OPA4187IPWR

It is possible to reduce the output level.

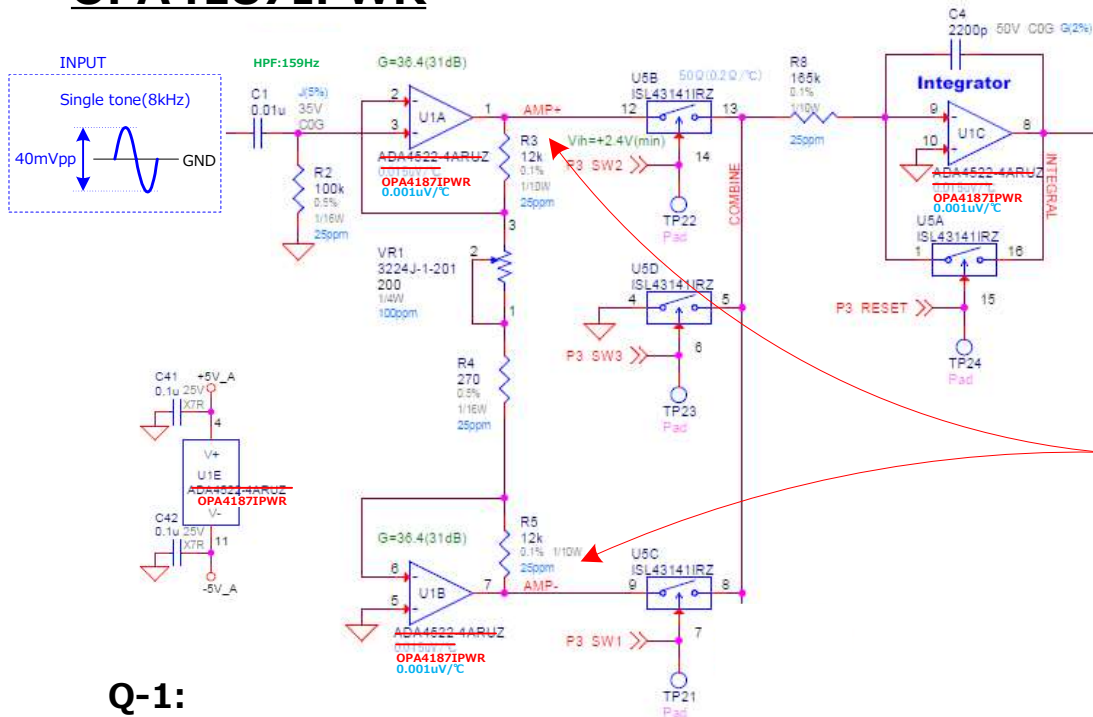
How much is the maximum gain?
It is possible to change R3,R4,R5 and VR1.

Q-1:

Currently, the input is 40mVpk.

Do you have a change to increase the input voltage swing, say 50-60mVpk at 8kHz, ?

Q-2:

What types of load that Output1 and Output2 are driving?

The output is a differential output or the load is Output1 - Output2.

Q-3:

Output signals have a slight phase shift from input signal as it is configured.

Are you concerned about the phase shift?

I assumed that it is important to have the voltage swing amplitudes of the 8kHz at the output.

A-1:

The input level(40mvpp) is fixed.

A-2:

At behind Output1 and Output2, detected and integrated.

So it is possible to reduce the output level by increasing the integration time.

A-3:

I don't mind the phase shift at all.
